## 2025 REVISION TABLE

(To the 2024 Electric Line Extension and Service Standards, Effective date of January 24th, 2025)

**DRAWING 12A - POST TYPE INSTRUMENT TRANSFORMER (CT & VT)  
METER INSTALLATION (FROM A CT CABINET)**

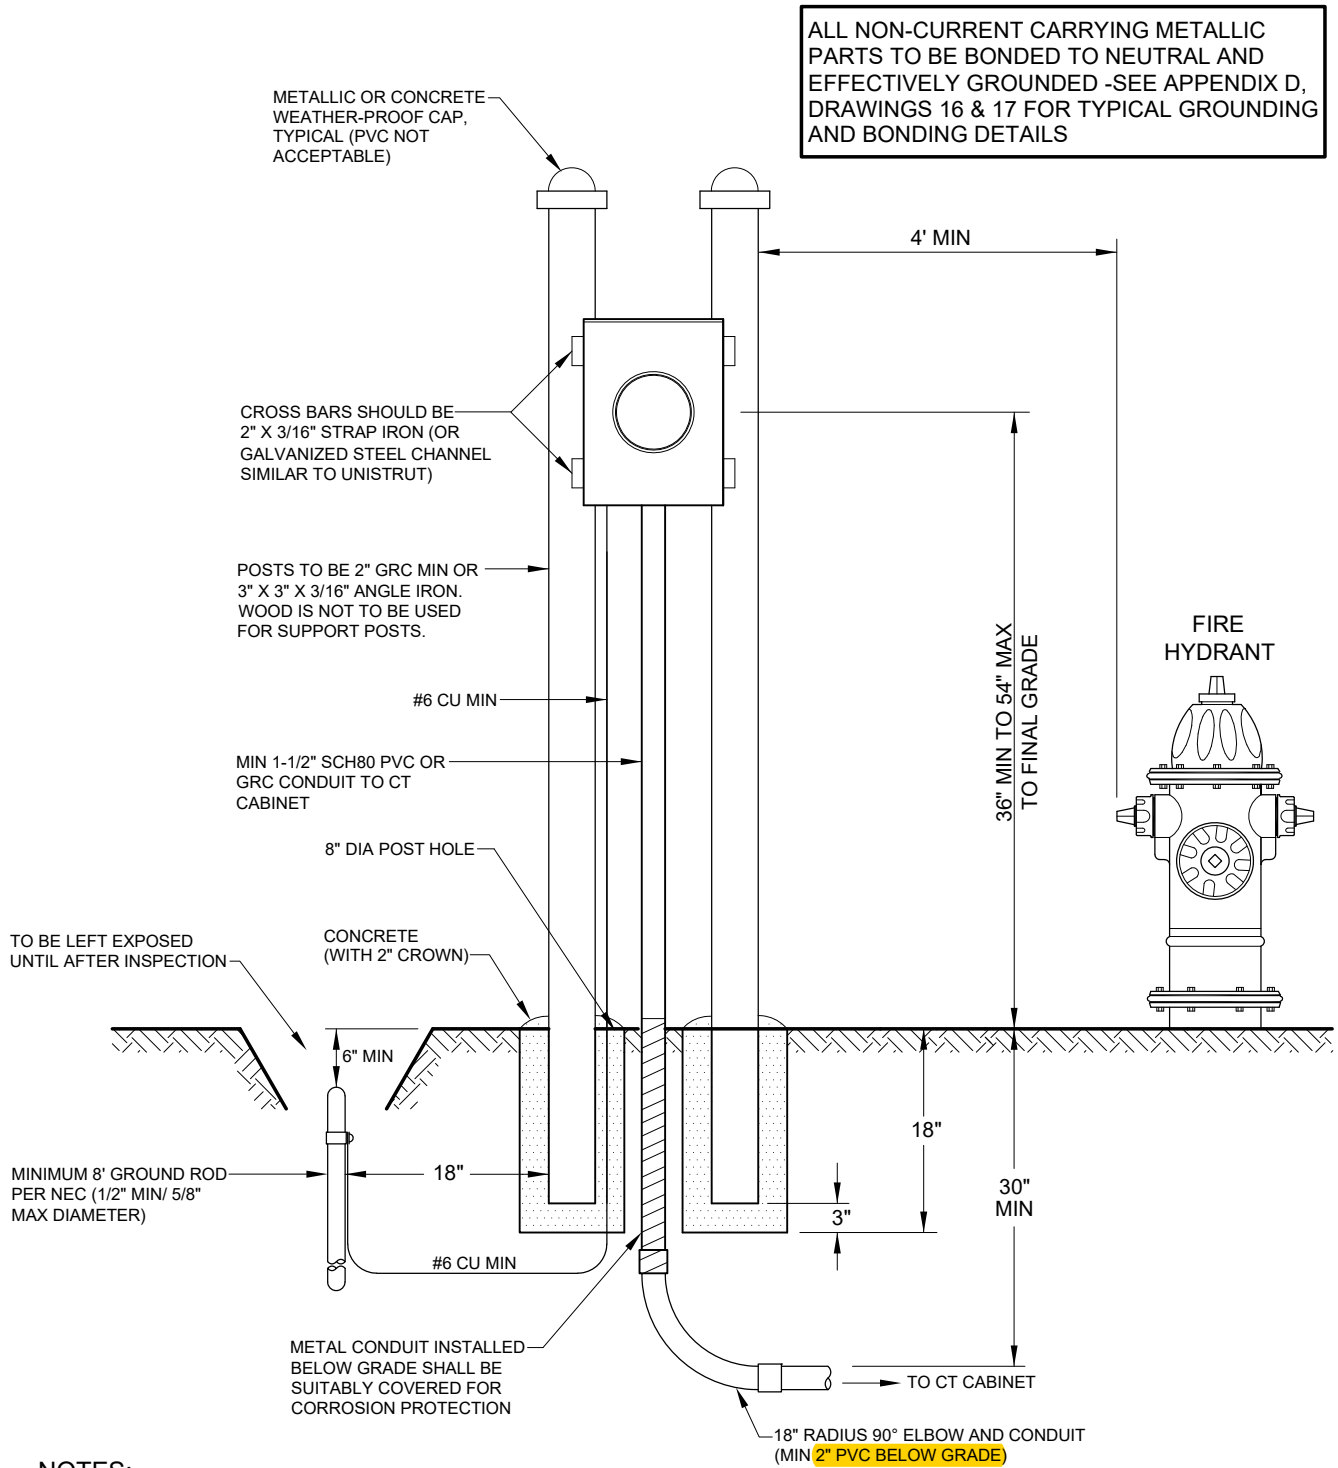
Christopher Sine, -Minimum conduit size for above ground vs below ground CT metering conduit. -Changed Maximum CT Conduit run length from 35' to 20'.	Appendix D, (Various)	(Various)	<ul style="list-style-type: none"> <li>-Appendix D, Drawings 12A, 12B, &amp; 13: 18" RADIUS 90° ELBOW AND CONDUIT (MIN <b>2" PVC BELOW GRADE</b>)</li> <li>-Appendix D, Drawings 14 &amp; 15: 1-1/2" SCH80 PVC OR GRC- <b>20'</b> MAX,OR EMT- 2' MAX</li> <li>-Appendix D, Drawing 19: <b>20'</b> MAX and note 7: The CT meter conduit shall be no longer than <b>20 feet (total length of conduit including all bends)</b></li> </ul>
Christopher Sine, Line/ Load Side feed on Overhead vs Underground Services	Appendix D, Photo 1	PHOTO 1 – THREE PHASE CT CABINET	<b>For Overhead Services, Line Side must be on Top. For Underground Services, Line Side may be on the Bottom or Top.</b>
Elizabeth Ritchey, Clarify color options for AC Disconnect Switch	Appendix D, Photo 6	PHOTO 6 – PHOTOVOLTAIC SERVICE EQUIPMENT LABELING	Customer Provided "AC Disconnect" Placard on AC Disconnect Switch. <b>Color may be black text on yellow background or white text on red background.</b>

1. Meter to be mounted with a maximum distance (total length of conduit run including all bends) of 20' from instrument transformers (CTs & VTs), refer to paragraph 5.04e for instrument transformer conduit installation.
2. Both posts must be effectively grounded.
3. Refer to trench information, 10.1f (commercial).
4. Connect #6 copper conductor from ground rod to ground terminal inside meter enclosure; this ground is in addition to that which may be required by the Regional Building Department.
5. Provide pull line for instrument transformer (CT & VT) wire.
6. For 277/480 volt services, a VT ("VT Pack") is required.

## DRAWING 13 - INSTRUMENT TRANSFORMER (CT & VT) METERING INSTALLATION

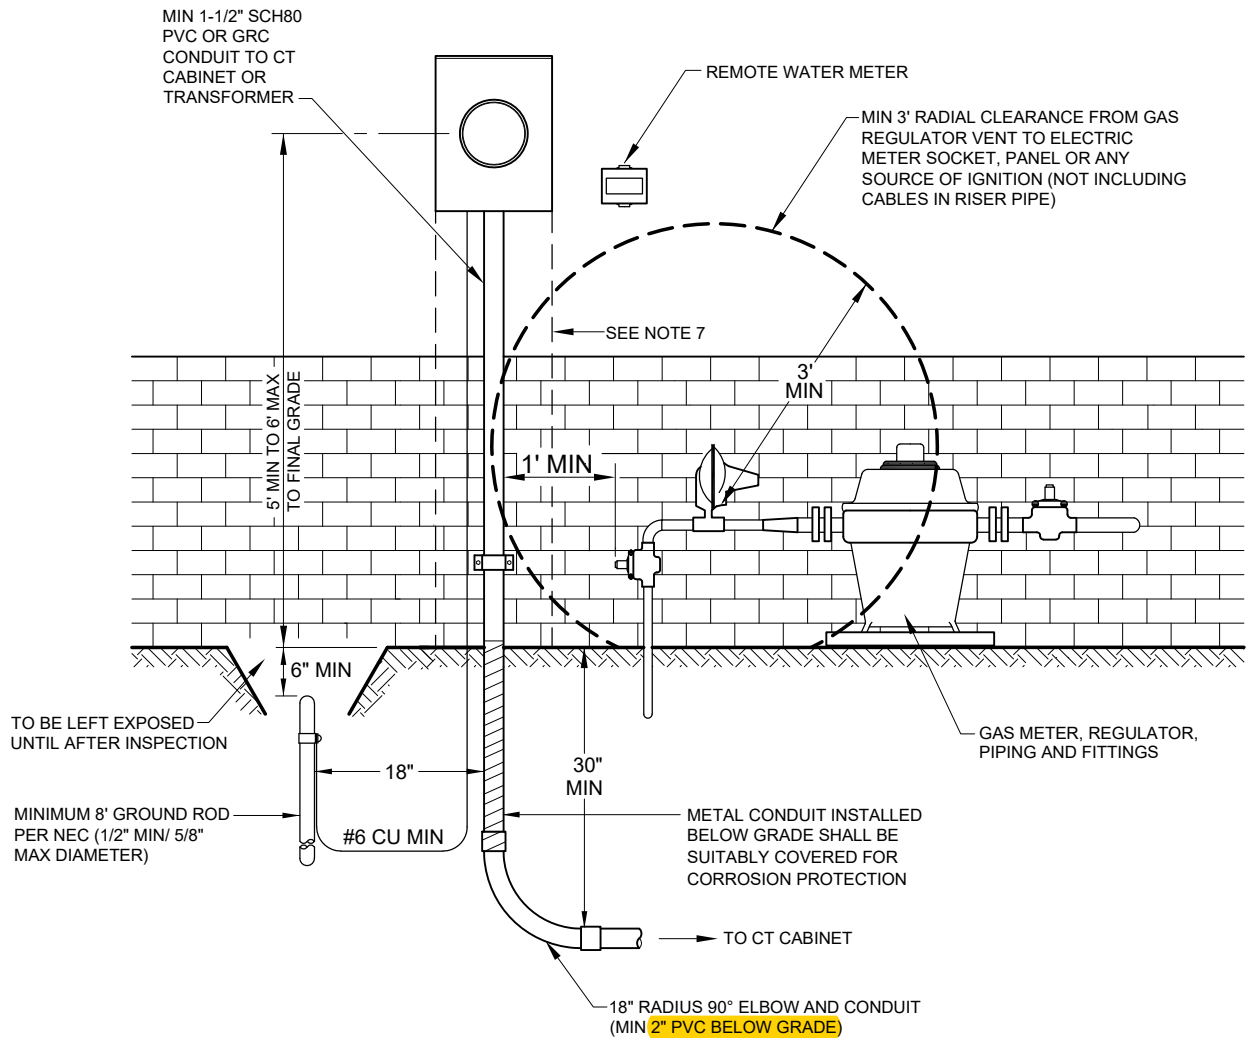
1. Meter to be mounted with a maximum distance (total length of conduit run including all bends) of 20' from instrument transformers (CTs & VTs), refer to paragraph 5.04e for instrument transformer conduit installation.
2. Conduit clamp must be above ground.
3. Refer to trench information, 10.1f (commercial).
4. Connect #6 copper conductor from ground rod to ground terminal inside meter enclosure; this ground rod is in addition to that which may be required by the Regional Building Department.
5. Provide pull line for instrument transformer (CT & VT) wire.  
For 277/480 volt services, a VT ("VT Pack") is required.
6. All above ground gas piping to be installed outside of meter socket (30" minimum) clear working space.

## DRAWING 19 - OUTDOOR COMMERCIAL SWITCHGEAR METERING OPTION

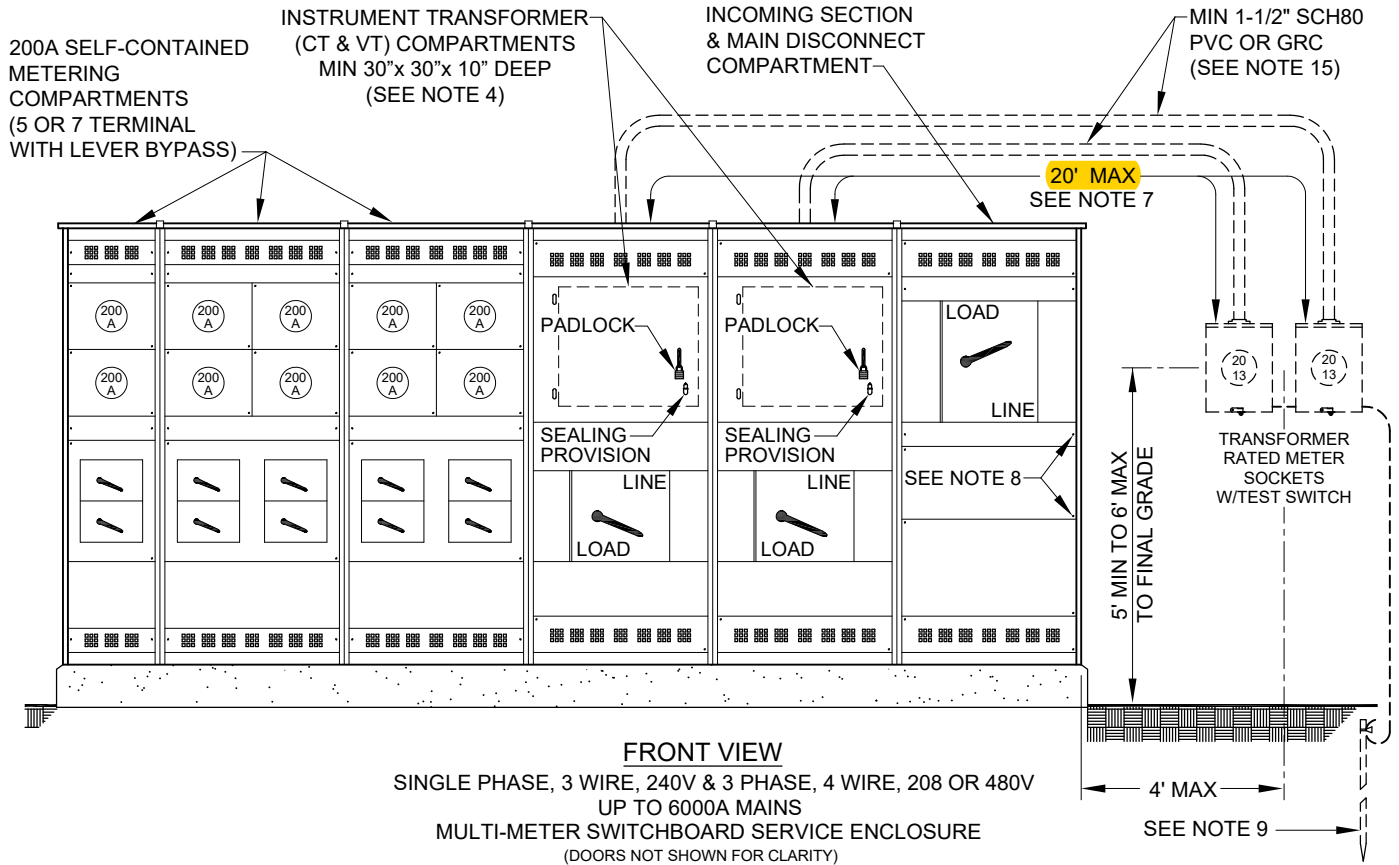
7. The CT meter conduit shall be no longer than **20 feet (total length of conduit including all bends)**. The conduit shall not have any conductors other than the required grounding/ bonding as shown in Drawing 17. Conduit must be contiguous from the meter socket to the switchgear CT cubicle, refer to paragraph 5.04e for instrument transformer conduit installation.

FIGURE 1

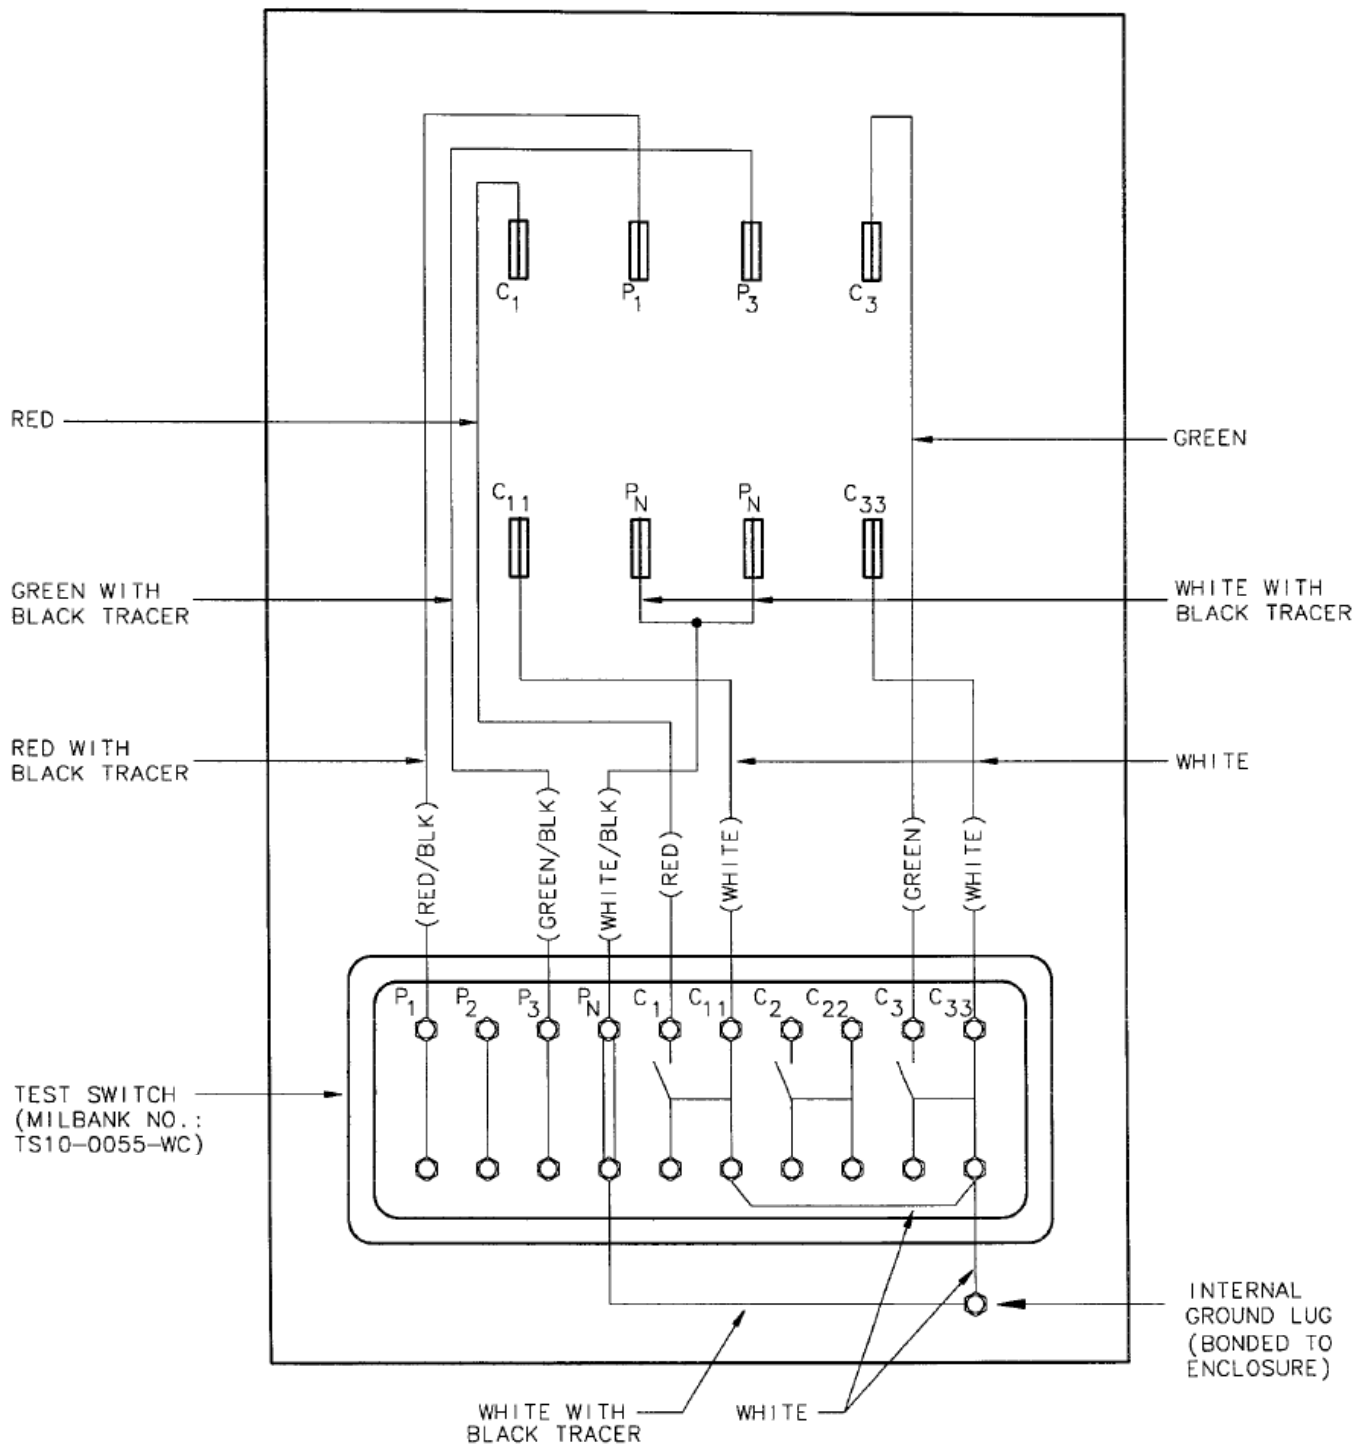
Toby Mijares, Updated specification 102-600-077	Appendix E, Material Specification	102-600-070 & 102- 600-077 Socket, Meter, Prewired Test Switch, 8 & 13 Terminal, 20 Amp	Updated Material Specification 102-600-070 & 102-600-077 Socket, Meter, Prewired Test Switch, 8 & 13 Terminal, 20 Amp
Toby Mijares, Add specification 102-700-(000-001) to Appendix E	Appendix E, Material Specification	102-700-(000-001) Switch, Color Coded Meter Test – (VARIES) Connected	Add Material Specification 102-700-(000-001) "Switch, Color Coded Meter Test – (VARIES) Connected" to Appendix E.
Bill Galloway and Adrian Pereida, Add specification 193- SPP-SCA to Appendix E	Appendix E, Material Specification	193-APP-SCA Generation Power Plant SCADA Panels	Add Material Specification 193-SPP-SCA "Generation Power Plant SCADA Panels" to Appendix E.

- 2.5.3. Color coding of conductors shall be as listed below (see Figure 1):
    - (P1): A Potential – red with black tracer
    - (P2): B Potential – not wired

PAVEMENT REPLACEMENT AND BACKFILL DETAIL

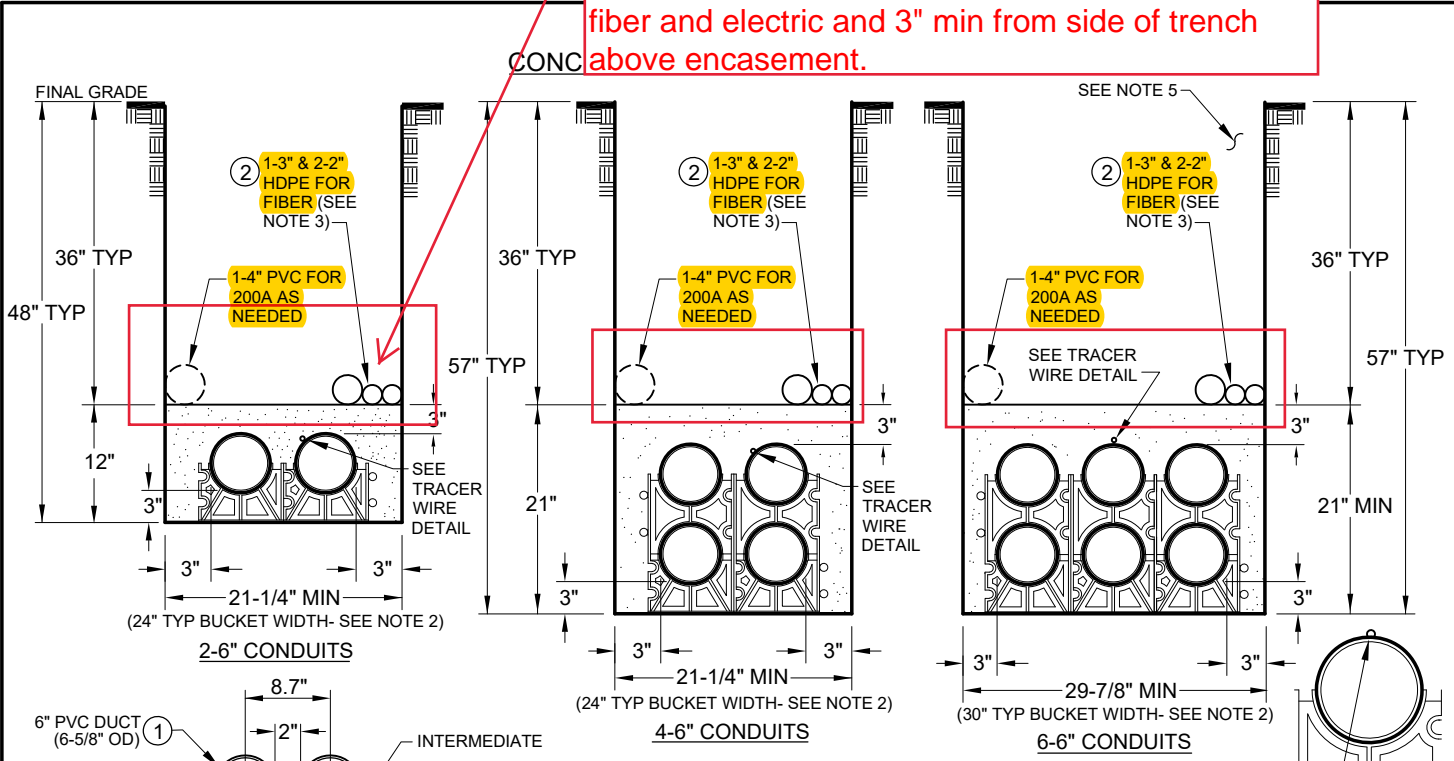
Updated notes in reference to conformance with City of Colorado Springs Public Works specifications.	Appendix F, 11-1	Trenching, Backfill/Compaction, Concrete Mixes, & Aggregate Base Course Materials	-Deleted notes 1 & 2 and moved note 6 to note 1 position. -Revised note 1 as follows: <b>"All work to be</b> in conformance with City of Colorado Springs Public Works specifications ( <a href="https://coloradosprings.gov/public-works/page/standard-specifications-manual">https://coloradosprings.gov/public-works/page/standard-specifications-manual</a> ). Refer to other authority if using state highway or county roads."
Updated notes and drawings for Fiber conduit and tracer wire. Added note about trench marking tape.	Appendix F, 11-2	Concrete Encased Duct Banks	-Updated notes and drawings for Fiber conduit and tracer wire. -Added trench marking tape note to drawing: <b>"INSTALL TWO RUNS OF 3" RED CAUTION TAPE, 12" ABOVE DUCT &amp; 1' APART (#100-136-036)"</b>

Deleted notes 1 & 2 and moved note 6 to note 1 position.

1. All work to be in conformance with City of Colorado Springs Public Works specifications (<https://coloradosprings.gov/public-works/page/standard-specifications-manual>), Refer to other authority if using state highway or county roads.
2. When suitable, use native material compacted as specified on page 2. If native soils are not suitable, install flowable fill, Colorado Springs T&D Mix #3 as specified on page 5.
3. Flowable fill is required for street crossing trenches one foot or less in width.
4. Utilize the boring crew/contractor when appropriate for recently repaved streets, etc.

**TRACER WIRE DETAIL**

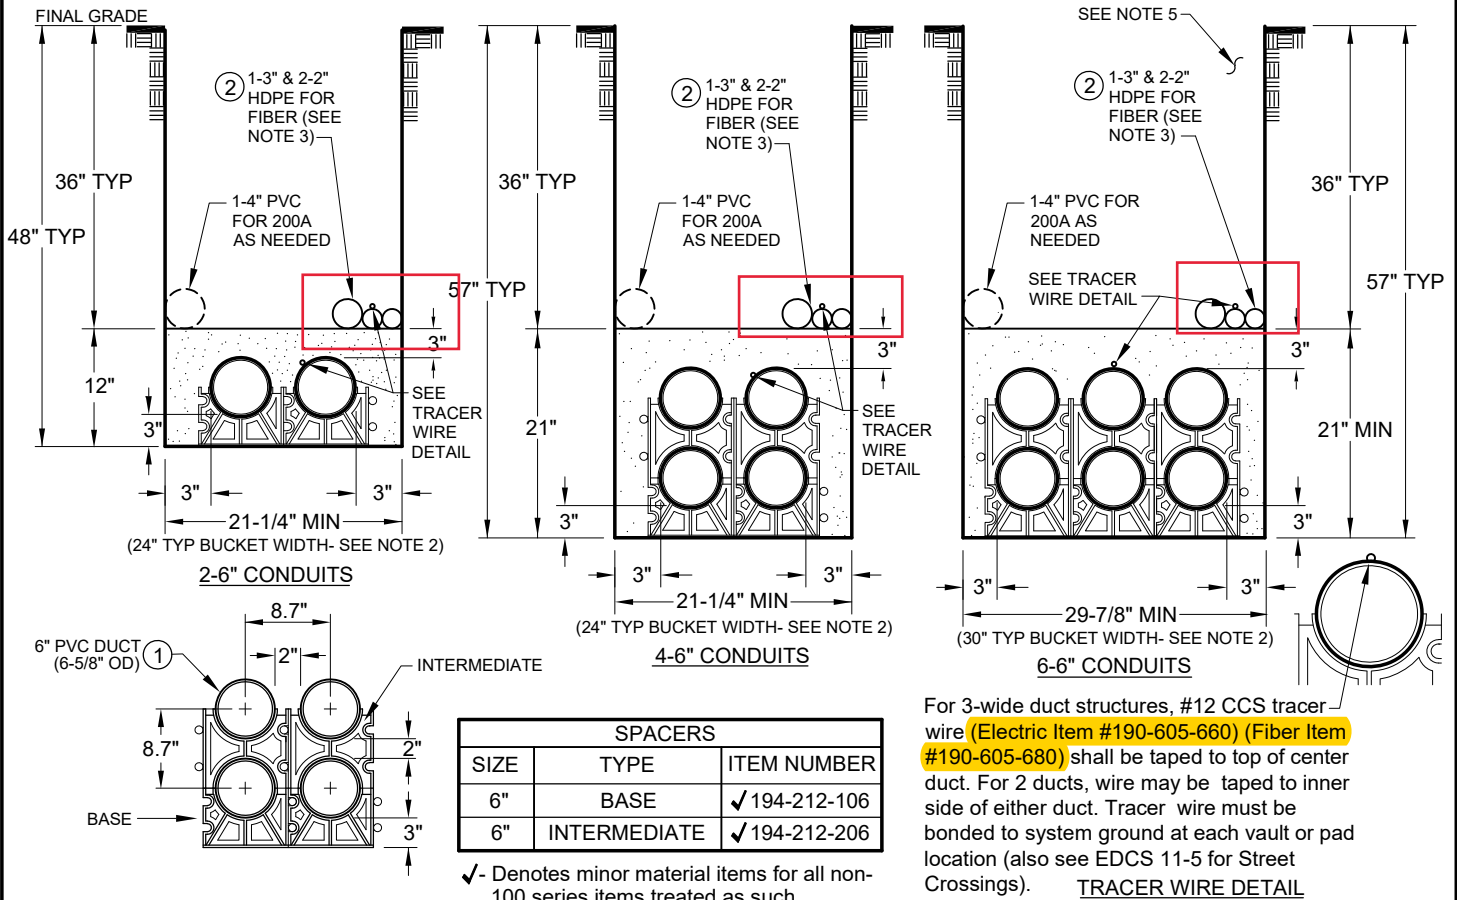
Added new section for Fiber Conduit.	Appendix F, 11-5	Tracer Wire for Empty Ducts	Added new section for Fiber Conduit.
Revised exception note about 3' clearance to Fiber, added note about horizontal clearance to fiber boxes, & updated note 2 for Joint trench with Utilities' Fiber.	Appendix F, 18-304	Clearances Of UG Electric Conduit/Cable from Other Facilities	Reformatted wording for Exception "e" that reduces clearance Telecom/ fiber to 3' when the requirements listed are met, emphasized the past requirement that high pressure gas main requires a 10-foot horizontal clearance with no exceptions, and added text <b>"The horizontal clearance distance applies to fiber appurtenances, to include boxes (boxes must be the required horizontal and vertical distance away from gas and electric and shall not be placed over electric or gas pipe)."</b>  Updated note 2: "These clearance matrix table dimensions are for separate trenches. <b>Joint trench between Gas and Colorado Springs Utilities Telecom./ Fiber requires a 1' radial separation. Joint trench between Electric and Colorado Springs Utilities Telecom./ Fiber requires a 3" in concrete and 6" in fill earth radial separation.</b> "

Removed old note 8 about 12" separation between fiber and electric and 3" min from side of trench above encasement.
